REVISION TO  
32S-3 SERVICE BULLETIN NO. 1

## SERVICE BULLETIN NO. 1

EQUIPMENT TYPE: 32S-3 TRANSMITTER

SUBJECT: IMPROVE VOX CIRCUIT TO ELIMINATE INTERMITTENT DROPOUT, AND IMPROVE OPERATION OF FIRST AUDIO AMPLIFIER

32S-3 Chassis, Partial View Showing Location of Components Affected by This Modification

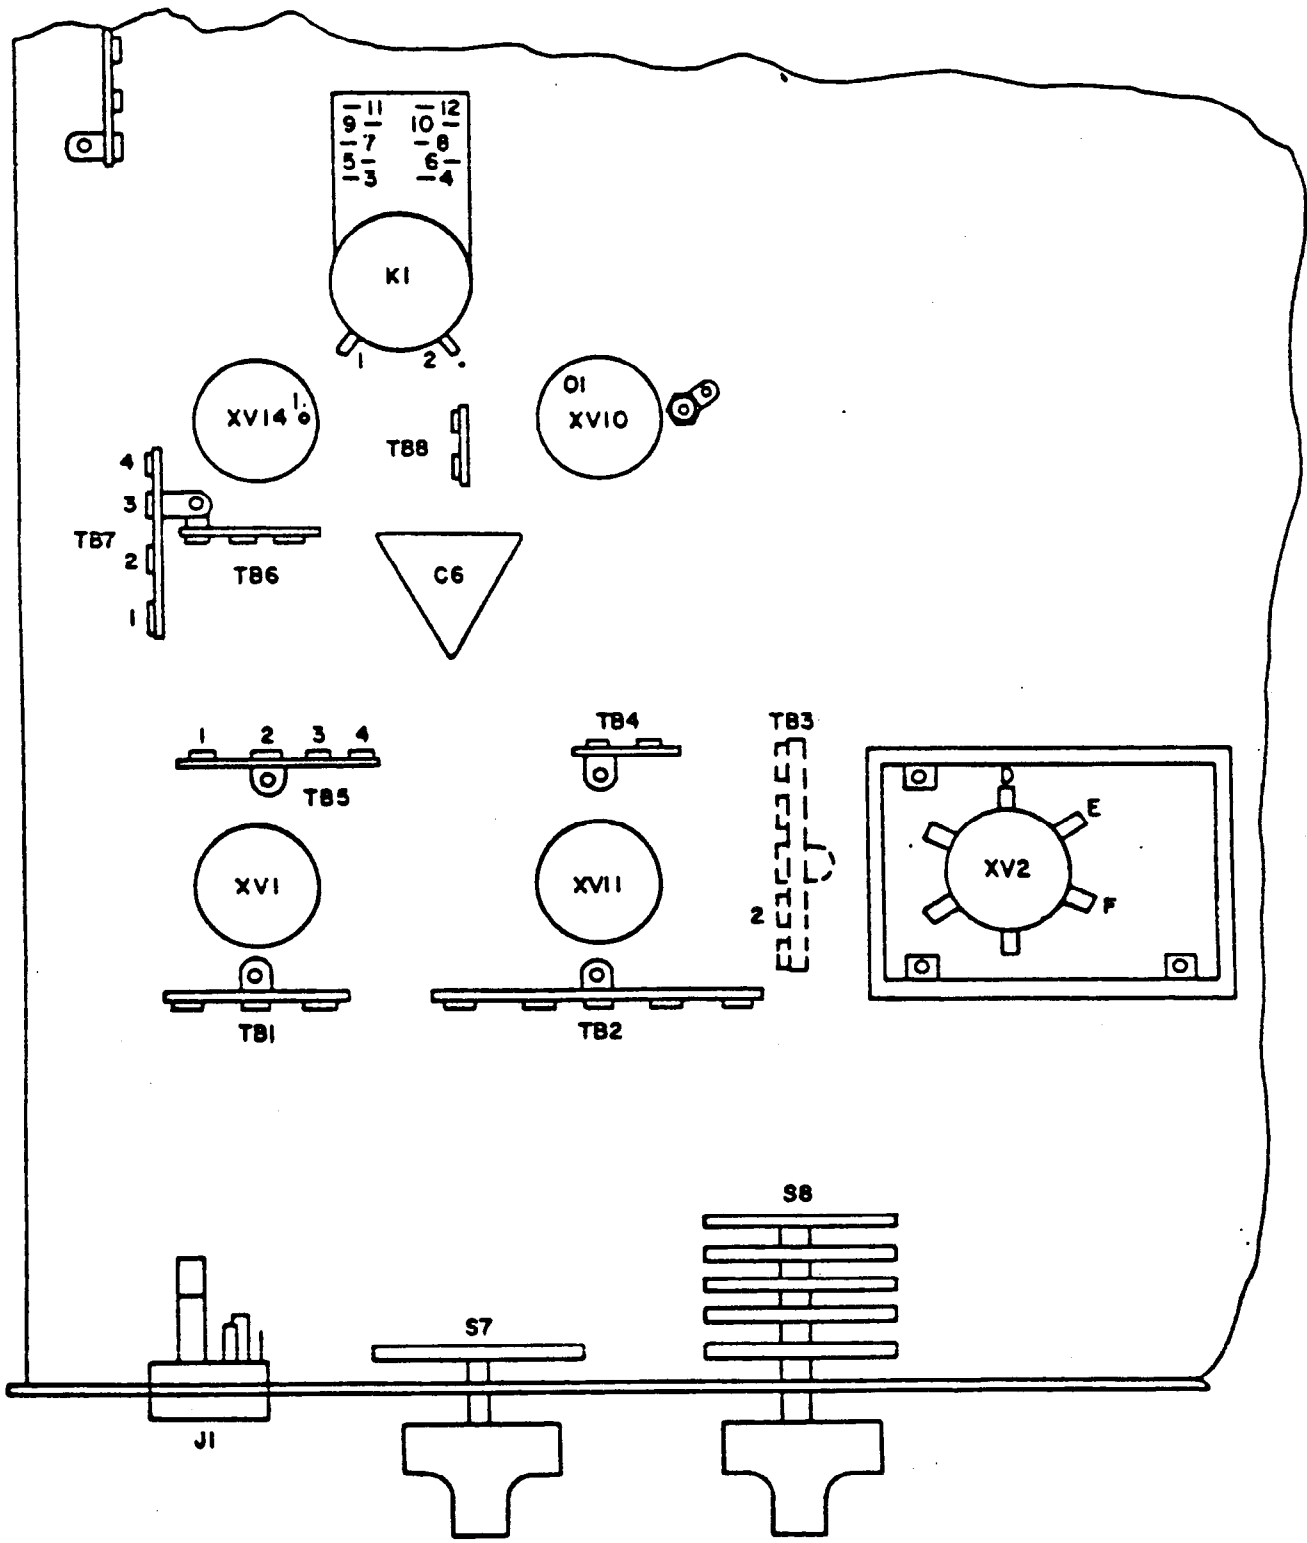
1. Substitute new 47K resistor R138 (745-1422-000) for choke L1. The choke is connected between tube socket XV1, pin 9, and terminal strip TB1.
3. Substitute new 100K resistor R101 (745-1436-000) for 1-megohm resistor R101. This resistor is located on terminal strip TB1.

4. Connect new 0.1-uf capacitor C188 (913-3152-000) between XV1, pin 8, and the ground terminal of terminal strip TB5.
5. Substitute new 0.02-uf capacitor C119 (913-2142-000) for 0.1-uf capacitor C119. Capacitor C119 is located between tube socket XV10, pin 5, and terminal 11 of relay K1.

6. Connect two new 0.1-uf capacitors C186 and C190 (both 913-3152-000) in parallel between XV10 pins 5 and 7.
7. Connect new 20-uf capacitor C184 (183-1165-000) between XV14, pin 8 (positive lead), and TB7, terminal 3 (negative lead).

8. Connect new 20-uf capacitor C185 (183-1165-000) between XV14, pin 3 (positive lead), and TB5, terminal 2 (negative lead).
9. Substitute a new 220K resistor (745-1450-000) for 680K resistor R73. Resistor R73 is connected between XV2, pin 9, and TB3, terminal 2. Transmitters that have a shield around XV2 do not have a terminal board TB3, and R73 is connected

between XV2, pin 9, and XV2, terminal F. To remove the shield, disconnect the choke L2 lead from XV2, terminal E, and the capacitor C92 lead from XV2, terminal D. Remove the three screws that secure the shield in place. These screws are removed from the top of the chassis. After R73 has been replaced, reconnect the component leads to the original terminals, and replace the shield.

10. Substitute new 6-pf capacitor (916-0122-000) for 3-pf capacitor C28 (see figure 6-8, fourth edition of 32S-3 Transmitter Instruction Book, for location of C28).
11. Locate and remove 20-uf capacitor C183 from FREQ CONTROL switch wafer S9F.
12. Replace transmitter chassis in cabinet and secure in place with the hardware removed in step 1.
